REVISION (1) TO SAFETY ANALYSIS REPORT (SAR)  
FOR LOW ENRICHED FUEL OF THE RHODE ISLAND NUCLEAR SCIENCE  
CENTER RESEARCH REACTOR

**ACTION:**

- 1) Replace pages 17 and 18 of the original document with  
new pages 17 and 18 CH-1
- 2) Replace Appendix C, pages 25 and 26, with new pages 25  
through 30 CH-1
- 3) Delete Appendix D, pages 28 through 32.

FIGURE 1-23 BEAM PORT

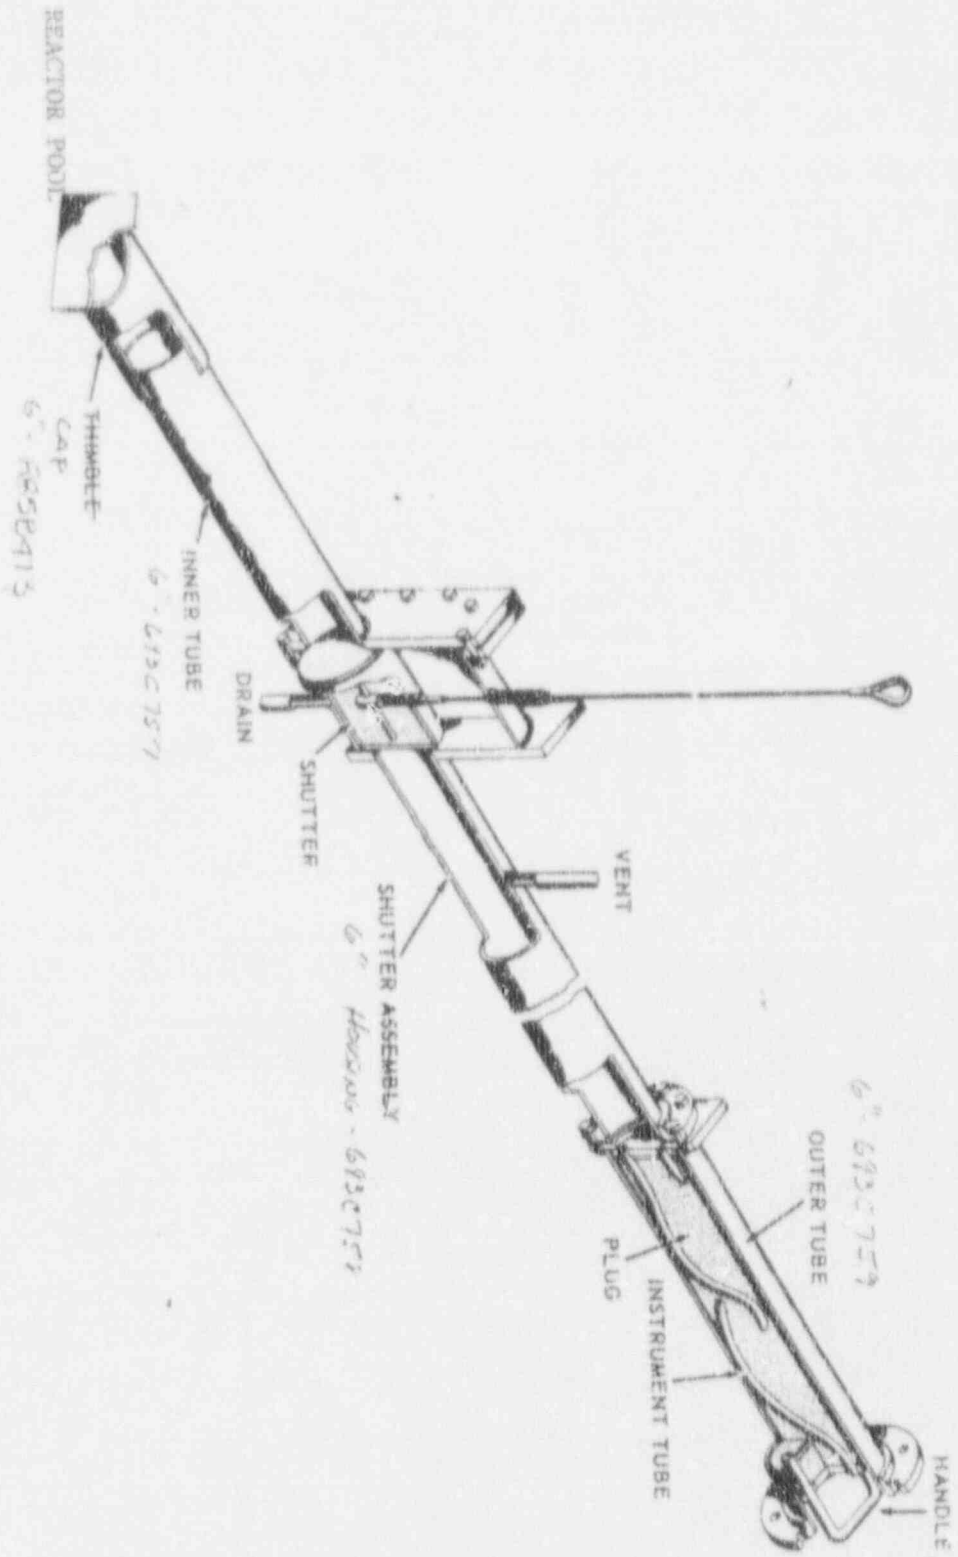
A typical beamport is shown in figure 1-23. Four barriers to loss of coolant can be provided; not all beamports have all four barriers. The first barrier is the beamtube itself. The fixed experiment barriers (one on each end) limit any leakage area such that a beamport failure will be less than the pool makeup fill rate of the hydraulic head imposed by the pool. The beamport shutter serves as another barrier, but the shutter is raised when a beamport is in use which eliminates its utility. Finally the flanged cover plate serves as a fourth barrier.

At the RI Reactor, every beamport or through tube is configured with at least two of the barriers. The through tube has two of the barriers; the through tube itself and a flange at each end. There are three six-inch beamports not in use having three of the barriers; the beamtube, the shutter in closed position, and a flange installed. The three remaining beamports have a minimum of two barriers; the beamtube itself and the experimental barrier(s) described above.

Appendix A shows the calculations leading to the result that no experiment will be approved or installed with a barrier having an opening greater than the equivalent area of a 1/2 inch diameter hole. The fixed experiment also implies that it shall be designed and installed to withstand the backpressure equivalent of the hydraulic head of the pool, or a minimum of 25.09 feet of water pressure.
